Facility Improvements-PHI (Site Improvements)

Project: GS 383-001

ADDENDUM NO. 2:

Date of Addendum:
August 30, 2019

Date:	17 JUNE 2019
Scale:	AS SHOWN
Drawn:	SLH
Approved:	WAD
Job:	1804
Sheet:	C101
Of	Sheets

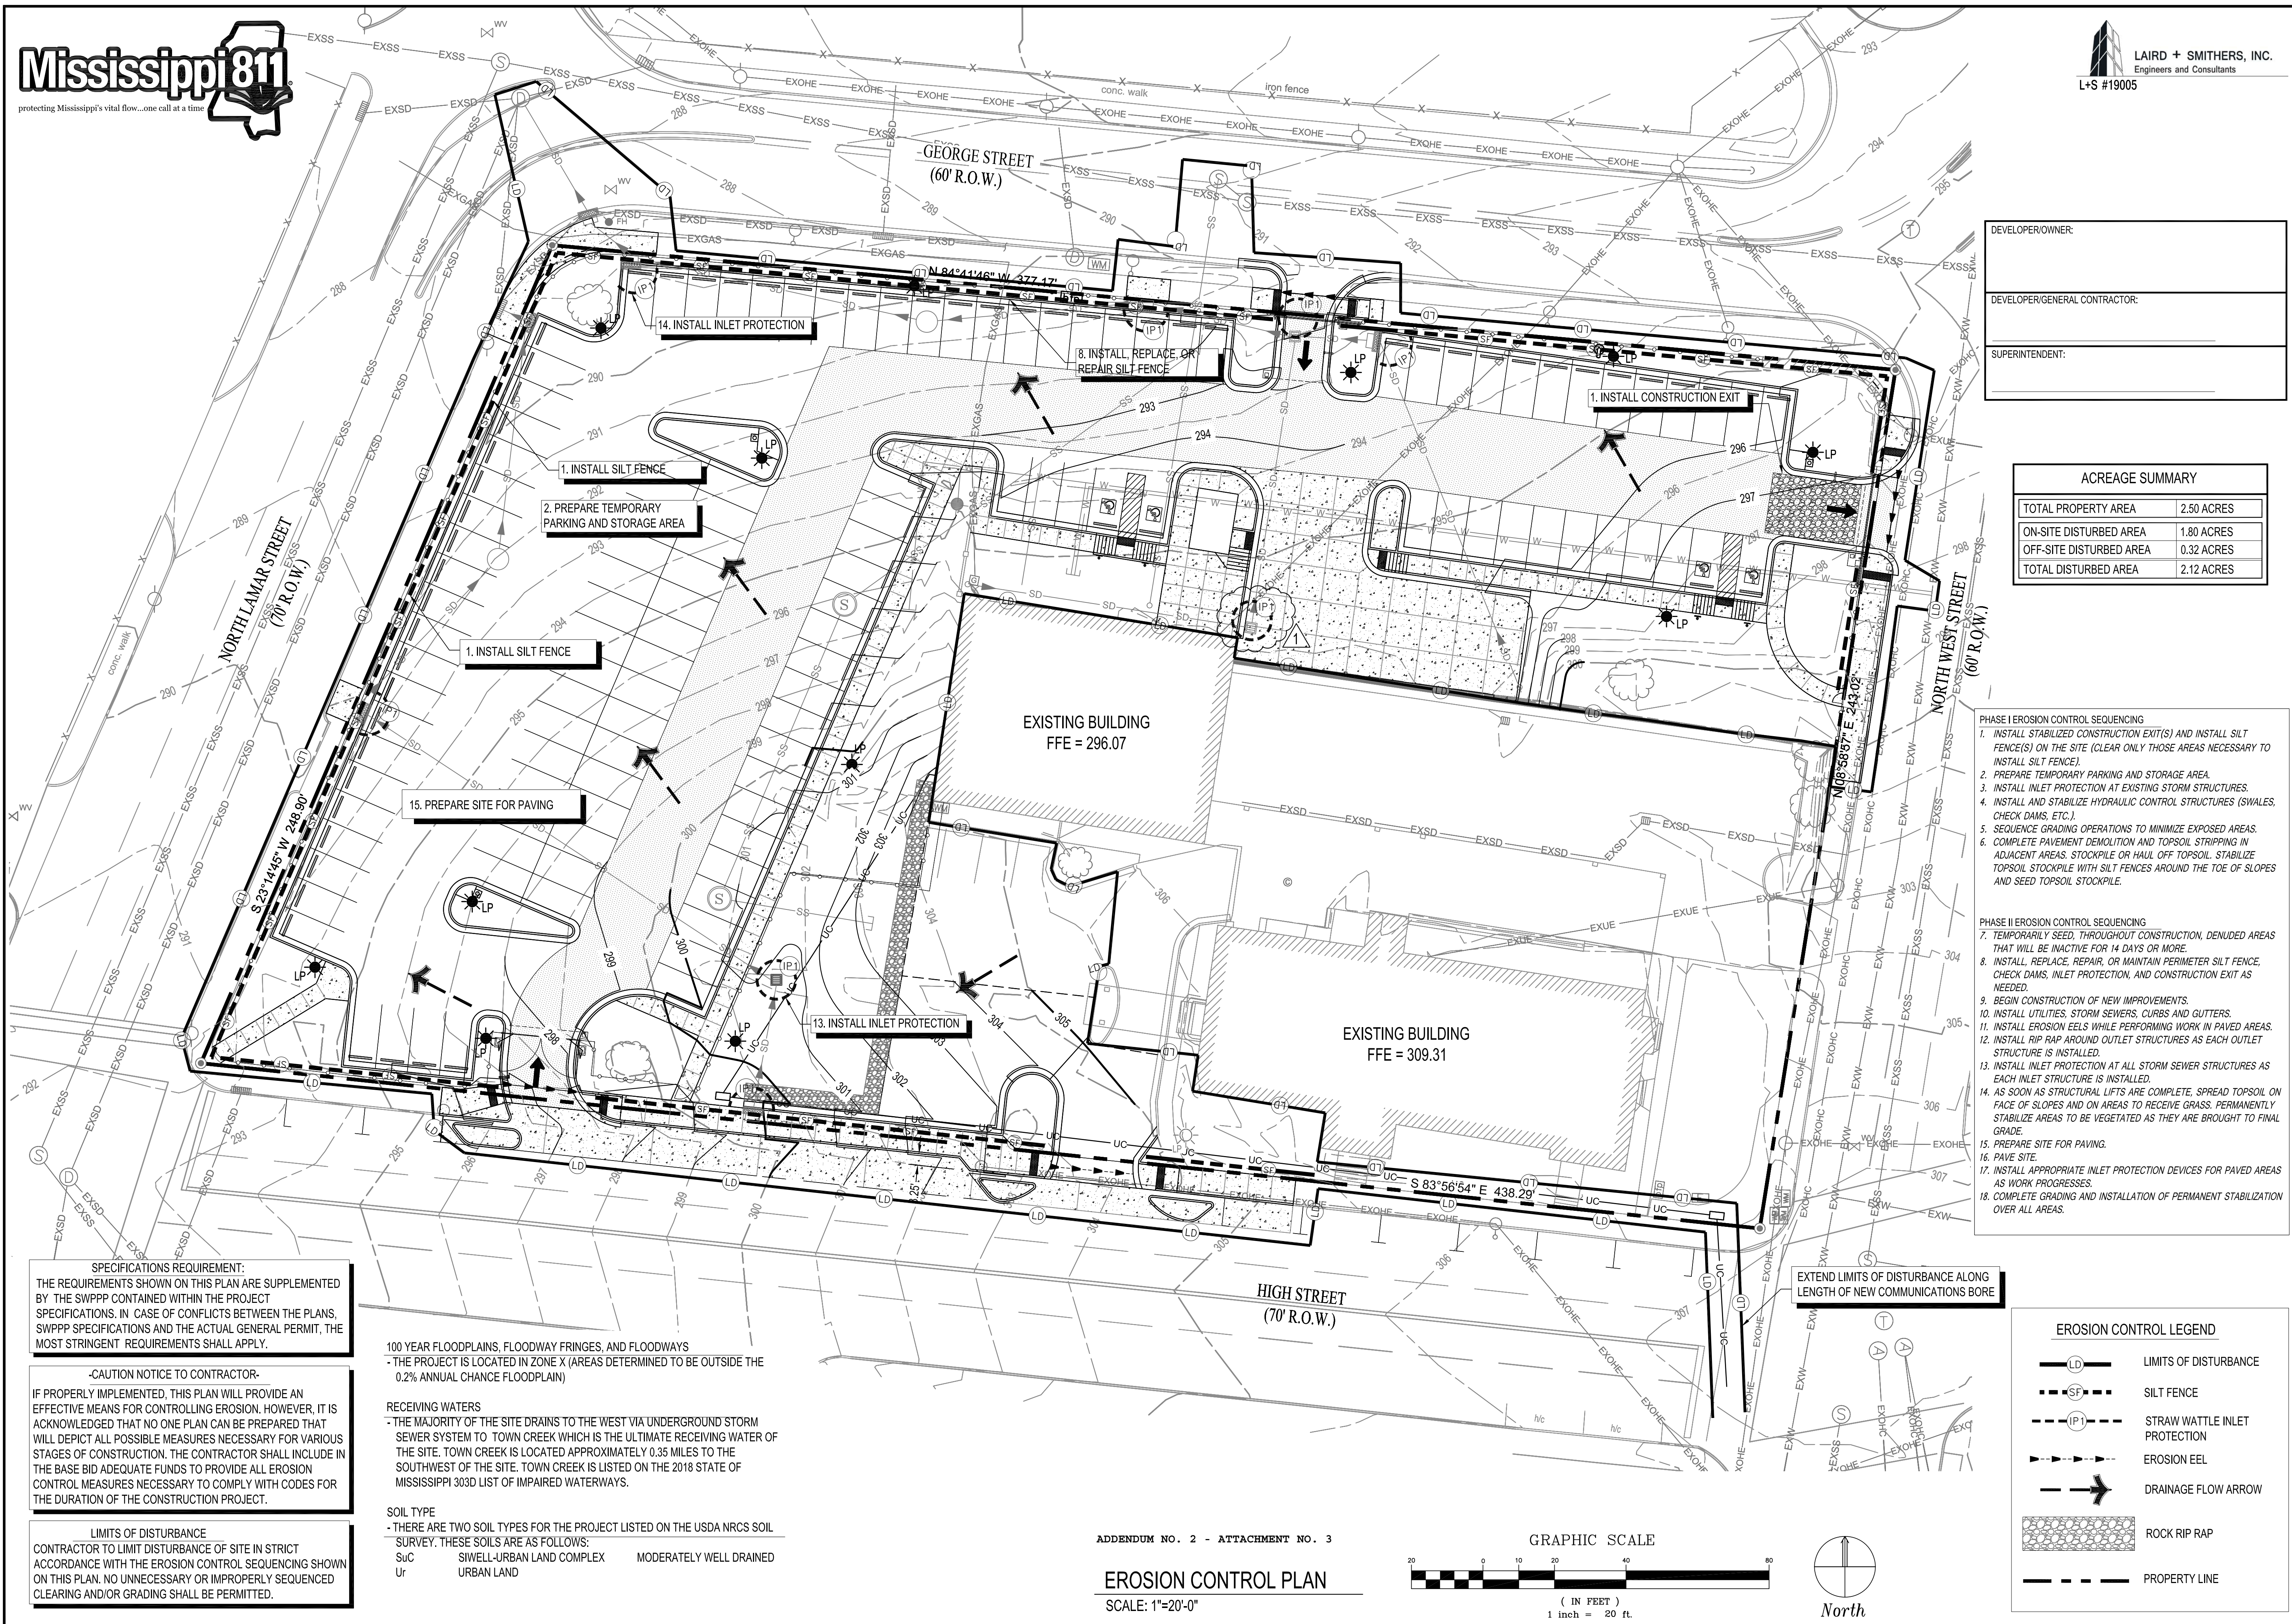
Item No. 2 **Drawings, Sheets C101, C121, C131, C132, C141, C205:**
Replace: Replace Sheets C101, C121, C131, C132, C141, and C205 with Sheets C101, C121, C131, C141, and C205 included at this Addendum as Attachment No. 3.

Date:	17 JUNE 2019
Scale:	AS SHOWN
Drawn:	SLH
Approved:	WAD
Job:	1804
Sheet:	C121
Of	Sheets

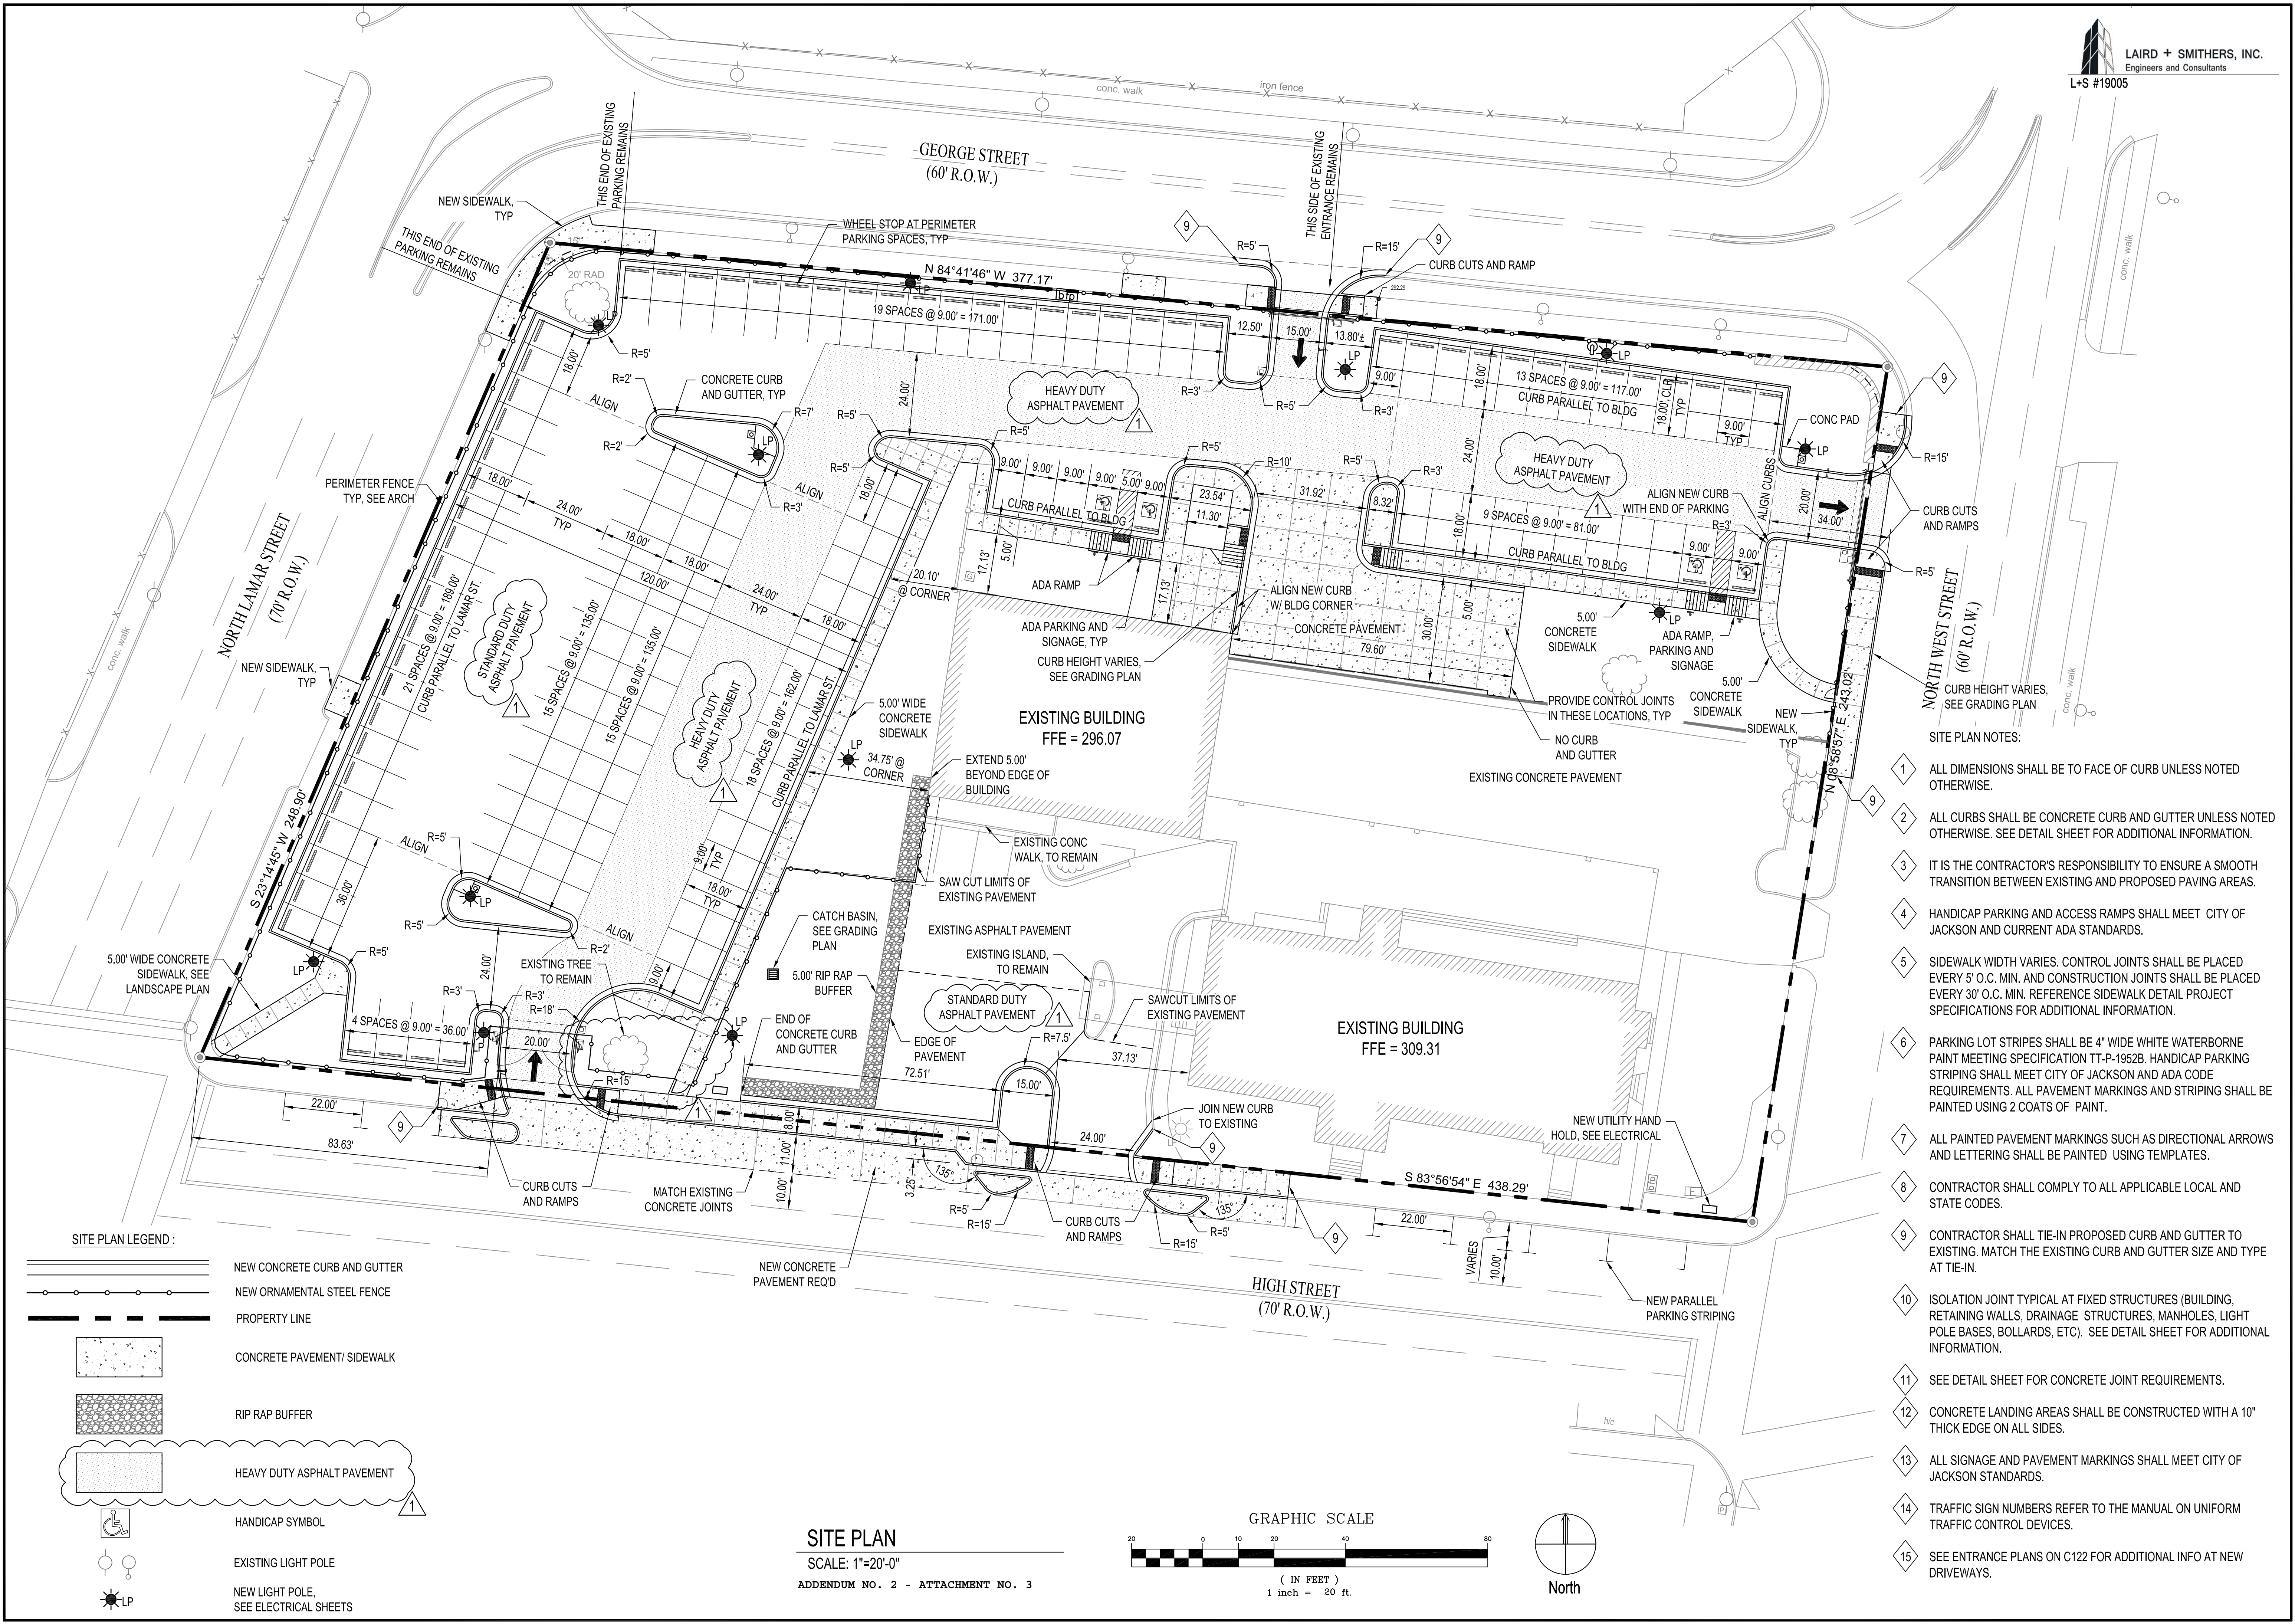
EXTEND LIMITS OF DISTURBANCE ALONG LENGTH OF NEW COMMUNICATIONS BORE
